**FIRE CODE / LAND USE / BUILDING REVIEW  
APPLICATION**

Applicant Name: Carrie Brennecke, MIG  
Address: 506 SW 6<sup>th</sup> Avenue, Suite 400, Portland, OR 97204  
Email: cbrennecke@migcom.com  
Site Address: 17160 SW Baseline Road, 1065 SW 170th Avenue  
City: Beaverton  
Map & Tax Lot #: 1S106DB02500, 1S106DB00400  
Business Name: n/a  
Land Use/Building Jurisdiction: Beaverton  
Land Use/ Building Permit # not yet available

TVFR Permit # 2022-0123  
Permit Type: SPP- COB  
Submittal Date: 9/28/2022  
Assigned To: DFM FOSTER  
Due Date: 10/11/2022  
Fees Due: MERRL  
Fees Paid: Ø

FIRE ACCESS PLAN / FIRE MARSHAL REQS.

1 SITE PLAN - PAVING AND FIRE ACCESS PLAN

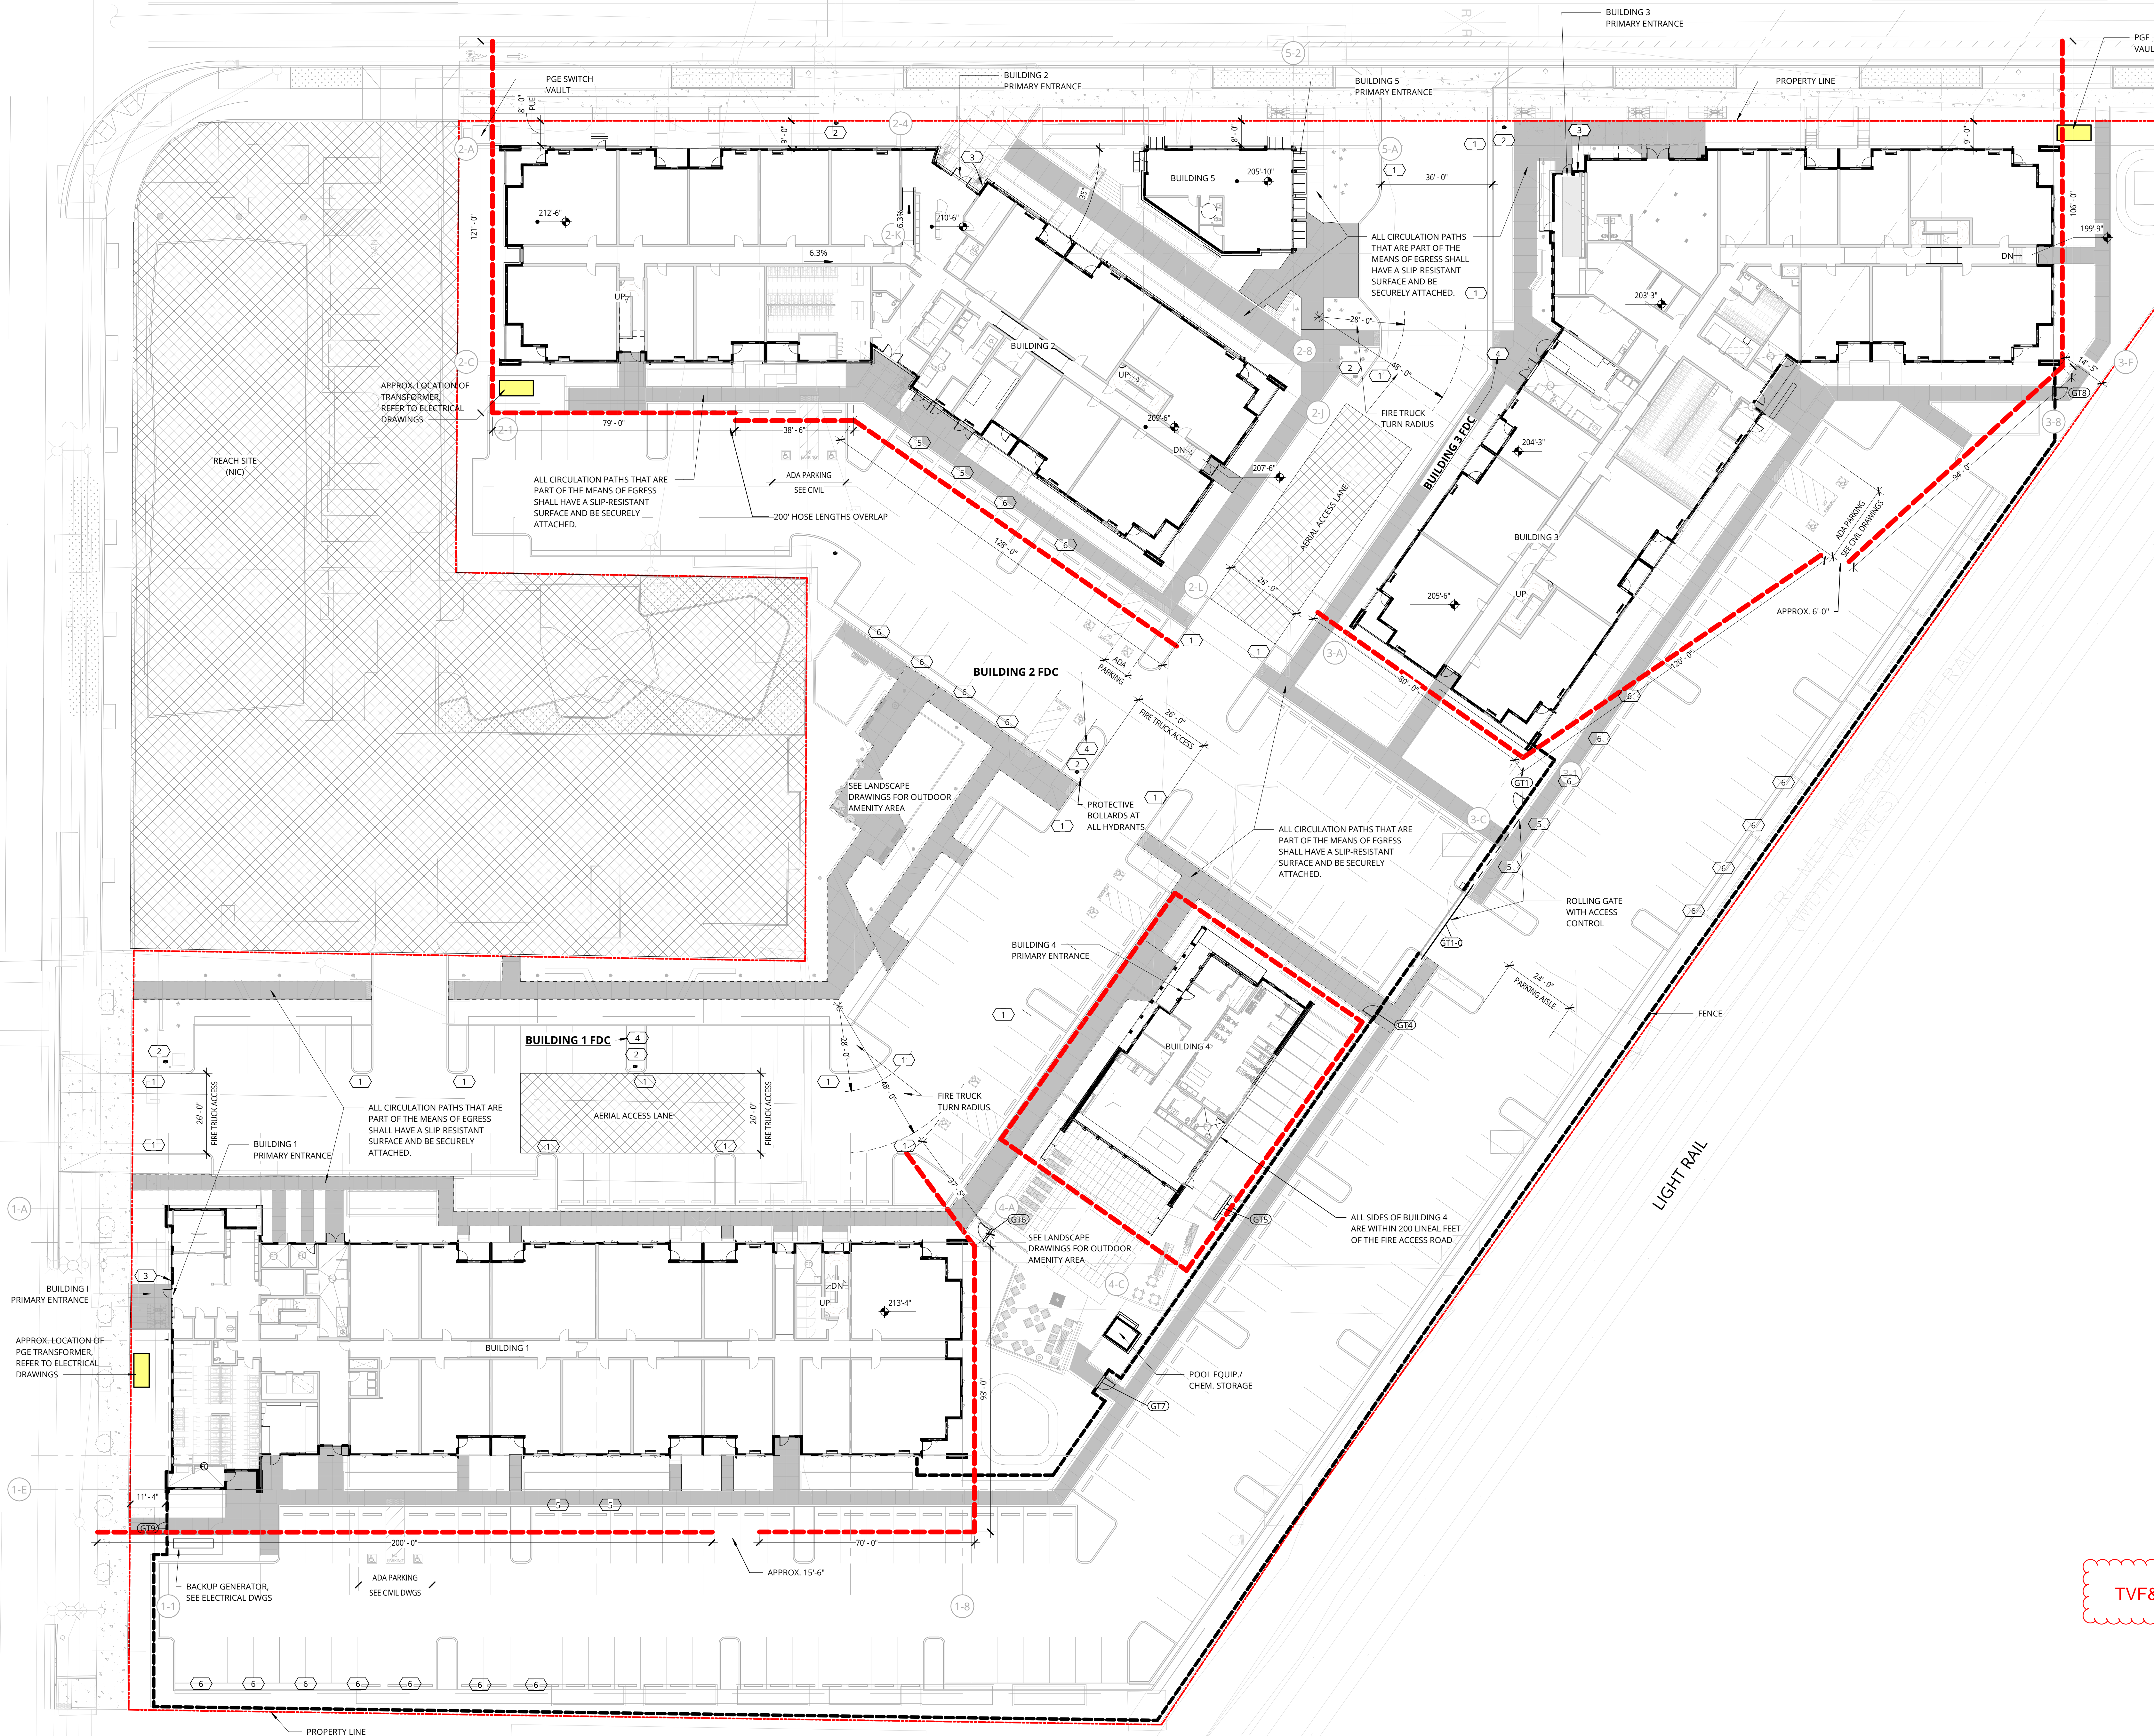
Notes: MERRC fees must be paid to TVF&R prior to building permit issuance. Also, a final inspection is required for this project from TVF&R.
